Z-61
(2014)

Preliminary Plan Woodlawn Drive Community

PETITION NO.: Z-61

ZONING COMMENTS:

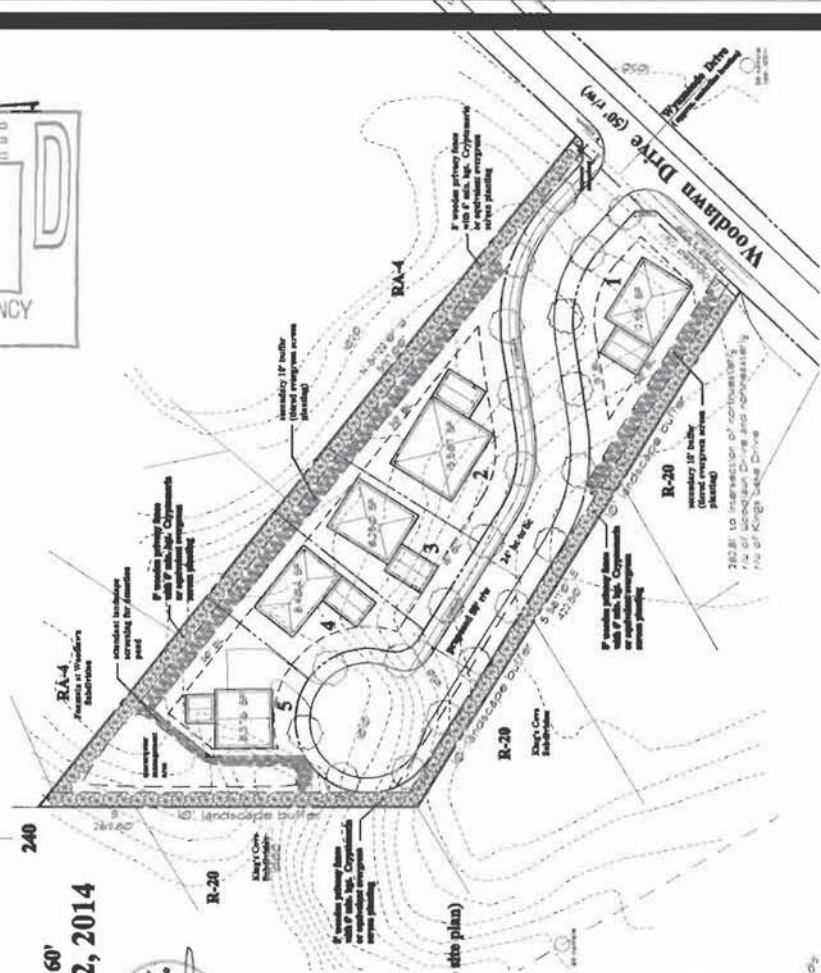
1. The entire site drains to the northwest into the Kings Cove Subdivision. However, there is no existing drainage easement to convey concentrated discharge from the site. The applicant is working with downstream property owners to obtain an easement to tie into the existing downstream storm system on Kings Lake Drive.
2. As indicated under Downstream Conditions, there is a private lake located approximately 500 feet downstream within the Kings Cove Subdivision. A pre- and post-sediment survey will be required.

Woodlawn Drive is classified as a minor collector and according to the available information the existing right-of-way does not meet the minimum requirements for this classification.

Recommend applicant consider entering into a development agreement pursuant to O.C.G.A. 36-71-13 for dedication of the following system improvements to mitigate traffic concerns: a) donation of right-of-way on the northwest side of Woodlawn Drive, a minimum of 30' from the roadway centerline.

Recommend curb and gutter along both sides and sidewalk along one side of proposed development roadway.

Recommend a taper for the Woodlawn Drive access.

Recommend applicant verify that minimum intersection sight distance is available for Woodlawn Drive access and if it is not, implement remedial measures, subject to the Department's approval, to achieve the minimum requirement of 390 feet.

Recommend development street either directly align or have an offset of a minimum of 125 feet from Wynmeade Park per Development Standard 401.10.

2. The subject property shall be developed in substantial conformity to that certain revised site plan, prepared by DGM Land Planning Consultants, which is being submitted contemporaneously herewith.

- a. As reflected on the revised site plan, the alignment of the proposed subdivision's entrance with Wynmeade Drive.³
 - b. The voluntary donation and conveyance of right-of-way so that the County can achieve an additional five feet (5') from the subject property's side of Woodlawn Drive.

- d. Insuring appropriate sight distance of three-hundred ninety feet (390') or the implementation of remedial measures in which to mitigate same.
 - e. The installation of sidewalks on one side of the interior street within the proposed subdivision.

- a. The ultimate location and configuration of on-site detention, stormwater management and water quality components. As presently shown, the stormwater management area is positioned on the subject property in accordance with recommendations from the Stormwater Management Division. Capital City and subsequently the Mandatory HOA shall be responsible for ensuring that the stormwater management area is treated and/or free of mosquitos.

- c. The Stormwater Management Area on the subject property will be sized and configured to ensure that the subject property is over-detained. As a function of Plan Review, the Stormwater Management area may be partially located underground.
